KRB STUDY REQUEST 6: *Tunnel Maintenance Flow*

RESPONSE TO COMMENTS

KRB SR-6: TUNNEL MAINTENECE FLOWS UPDATED STUDY PROPOSAL

²¹¹ See FERC eLibrary No. 19930127-0376 at image 30 [“Kern River 3 Powerhouse Capability Curve”]:

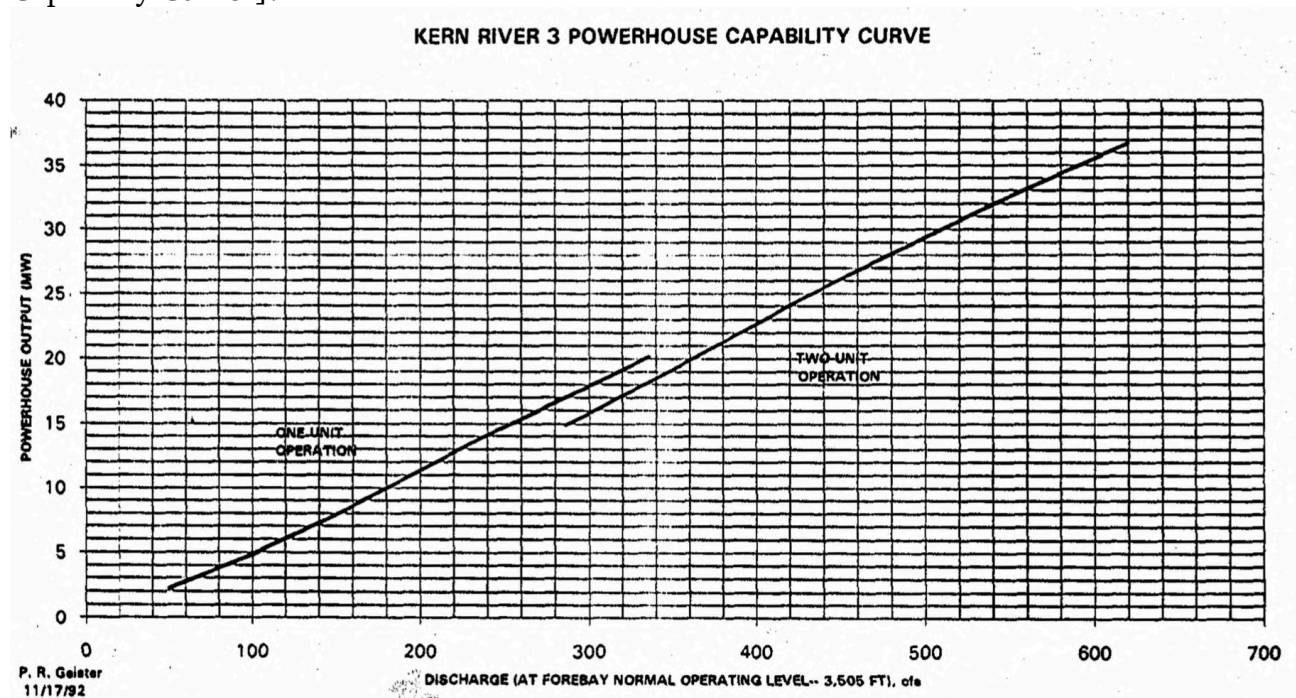
The purported study’s conclusion that 300 cfs is required to remain in the tunnel during rec days to prevent damage is controversial. Why is the required level for tunnel “integrity” 300 cfs instead of 250, or 200, or 150, or 100, or 50? Is the reason that 300 cfs is half of what Edison can divert, thereby strictly limiting the economic downside of mitigation? Is the reason that 300 cfs is the lowest quantity at which Edison can operate *both* of KR3’s turbines?²¹¹ Absent a scientific case for the selection of *that number, 300*, the number will continue to appear to be based on factors far afield of tunnel integrity. Indeed, Edison does not choose to limit its diversion to steady levels when the diurnal naturally results in a cycling of tunnel flows below 300 cfs; it only moves to “protect” the tunnels when mitigation comes into play. Absent the claims of recreation, Edison takes all the water it can get out of the river regardless of the diurnal’s cycling effects on its tunnels and accepts those effects as a cost of doing business. There is also no evidence that liner damage isn’t simply in the nature of transporting water over concrete. This proposed study seeks to take the place of the never-seen Edison study that animates the current 300 cfs mitigation cap. Finally, Edison indicates in the PAD that water does not crest the tunnel liner: “The tunnel segments [are] 8 feet high. . . . Water flow in the tunnel does not achieve a depth of greater than 7.5 feet, making lining of the arched ceiling unnecessary.”²¹² Edison also spent 16 months rehabilitating the tunnel liner in 2013-2014 to “improve” its integrity.²¹³ These
